**TOWN OF ERIE
TOWN BOARD OF TRUSTEES MEETING
December 8, 2020**

SUBJECT: **General Business:**
Redtail Ranch Sketch Plan

PURPOSE: Review and comment on a Sketch Plan application for a residential subdivision proposing 898 residential lots.

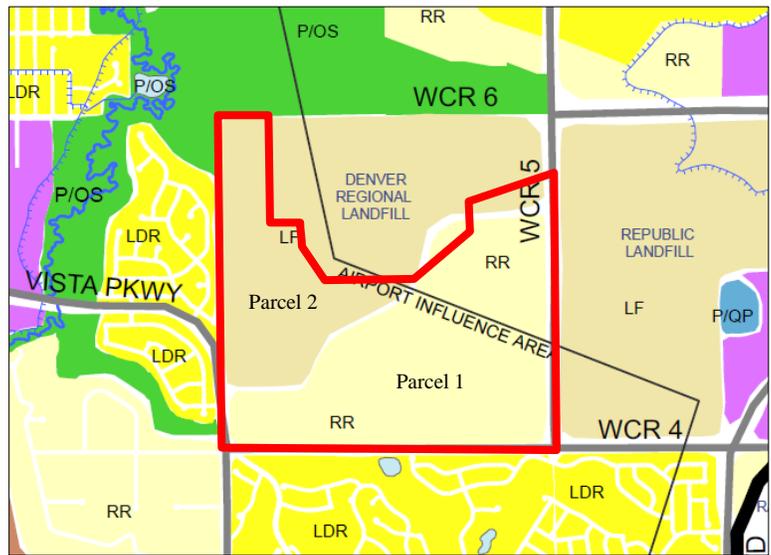
The Redtail Ranch Sketch Plan area is zoned both Public Land Institution (Parcel 2) and Low Density Residential (Parcel 1). The LR zoned area would allow residential development at a density of 5 du/ac, however, the Annexation Agreement restricts the maximum density to 2.2 du/ac. The applicant is proposing 898 dwelling units total within Redtail Ranch. 587 units are located on Parcel 1 (zoned LR), which would yield a density of 2.2 du/ac. That density is consistent with the current zoning and Annexation Agreement. Parcel 2 currently is not zoned for residential. A rezone to a residential zone district or PD zone would be required to allow for residential on Parcel 2. Parcel 2 is shown on the Sketch Plan with a proposed density of ~ 2.1 du/ac.

The sketch plan shows 3 housing types (duplex, townhome and single-family detached) and 3 housing type variations (alley loaded duplexes, single-family detached lot size: 5,000-9,999 SF and 10,000-39,999 SF)

Town of Erie Parks and Recreation staff has concerns on the Neighborhood Park location shown adjacent to the contamination site and are recommending relocation. Parks referral comments shall be taken into account regarding this concern with a future Preliminary Plat application.
